Re: Assessment of Proposed Development No: 2020/0302
41 Upper Clifford Avenue Fairlight.

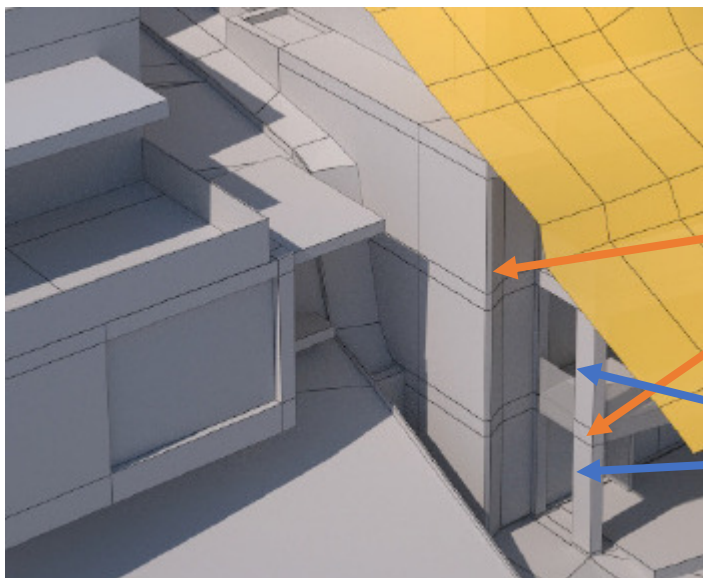
- 4.1.2.1 Wall Height, has Building B height assessed as non-compliant at 9m to the 3rd floor
- 4.1.2.2 Max stories has Building B non-compliant at 6 stories;
- 4.1.4.1 Street Front Setback which has Building B is 6.1m which is erroneously stated as compliant but does not comply with 4.1.4.1 of the DCP which states "Street Front setbacks must **relate to the front building line of neighbouring properties and the prevailing building lines** in the immediate vicinity".
- 4.1.4.2 Side Setback has Building B West being non compliant and exceeding the allowable amount by 47.6%

Page 25 section 3.4.1 access to sunlight and overshadowing is non-compliant and should not be listed as consistent with the aims and objectives. The assessment on page 26 states that "the submitted diagrams demonstrate that the proposed development will not lead to an unreasonable increase in overshadowing". The DA provided shadowing diagrams and analysis only for the winter solstice, which is extremely misleading as everything on the southern ridge is in shadow. Parts of the southern garden of 43 Upper Clifford Avenue will lose 5.5 hours of sunlight in spring or autumn because Building B protrudes around 2 meters further south on the western corner than the building on 43 Upper Clifford Avenue. .

This level of protrusion will cause overshadowing in Spring and Autumn, loss of privacy and loss of views.

The loss of privacy is based on having a person on their deck looking back into the bedroom window

Page 27 of the assessment has an objective to minimize loss of privacy to adjacent and nearby developments by mitigating direct viewing between windows. The DA with the current set back will allow anyone on the balconies to look back directly into the southern windows of our bedrooms and study as shown in the diagram above. This was not considered in the assessment.
